ROCHESTER GAS & ELECTRIC CORPORATION

Document Transmittal

Subject: Technical Requirements Manual (TRM) Revision 18

Technical Requirements Manual TRM

Figure TRB 3.7.7-1
SFP Cooling System

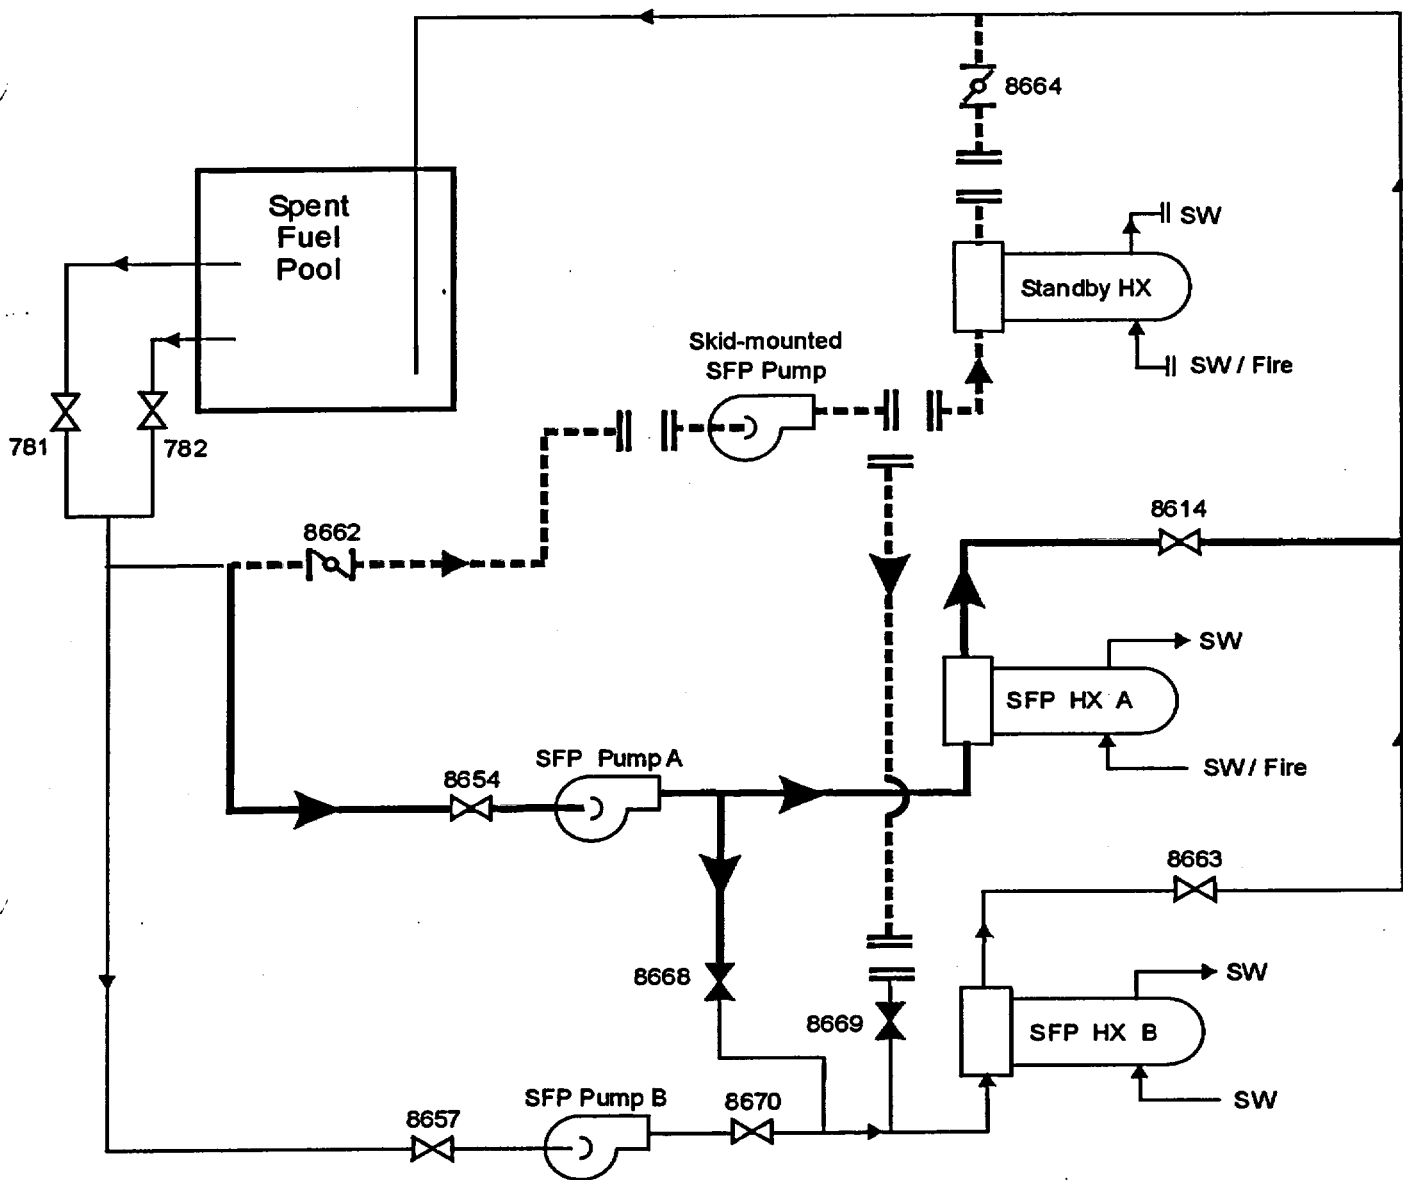
TRM sections TR 3.7.7, Spent Fuel Pool (SFP) Cooling System, and TR 3.9.4, Full Core Offload for Cycle 27, will be revised to provide the changes associated with PCR 2001-0036 and the Cycle 29 core offload. PCR 2001-0036 provides the ability to cross-tie the A SFP pump and/or the Standby SFP pump to the B SFP heat exchanger. Analysis has been generated supporting the timing of the Cycle 29 core offload.

The SFP Cooling System consists of three SFP pumps, two installed SFP heat exchangers, one SFP Standby Heat Exchanger (which is not normally used), and associated piping, valves, and hoses (see Figure TRB 3.7.7-1). The flow path starts at the common suction from the spent fuel pool to the three SFP pumps, through one or more SFP pumps and one or more SFP heat exchangers, and to the spent fuel pool via the common return line. The primary loop (SFP Loop B) is made up of the SFP Pump B, SFP Heat Exchanger B, and piping. The backup loops include:

There is also the ability to align the SFP Pump A and SFP Standby Pump individually or in parallel to the SFP Heat Exchanger B. Service water (SW) circulates through the shell while SFP water circulates through the tubes of the SFP heat exchangers. There is also the ability to provide fire water for cooling of the SFP Heat Exchanger A and SFP Standby Heat Exchanger. SFP Cooling System Loop B is sized for 100% of the design SFP heat load. SFP Loop A and the SFP Standby Loop are each capable of removing the normal basis heat load. When the SFP Pump A and the SFP Standby Pump are operated in parallel, through either their designated heat exchangers or through the SFP Heat Exchanger B, they can remove 100% of the design heat load (Ref. 1). Motor-operated valves provide automatic and remote manual isolation of the SW supply to the SFP heat exchangers. These valves close automatically upon coincidence of safety injection and loss of offsite power. Handwheels are provided for manual operation.

4. SFP Loop A (cross-connect)

- SFP Pump A has power available
- SFP Heat Exchanger B is capable of providing cooling water with the ability to remove the decay heat load of the irradiated fuel assemblies stored within the SFP

5. SFP Standby Loop (cross-connect)

- SFP Standby Pump has power available
- SFP Heat Exchanger B is capable of providing cooling water with the ability to remove the decay heat load of the irradiated fuel assemblies stored within the SFP
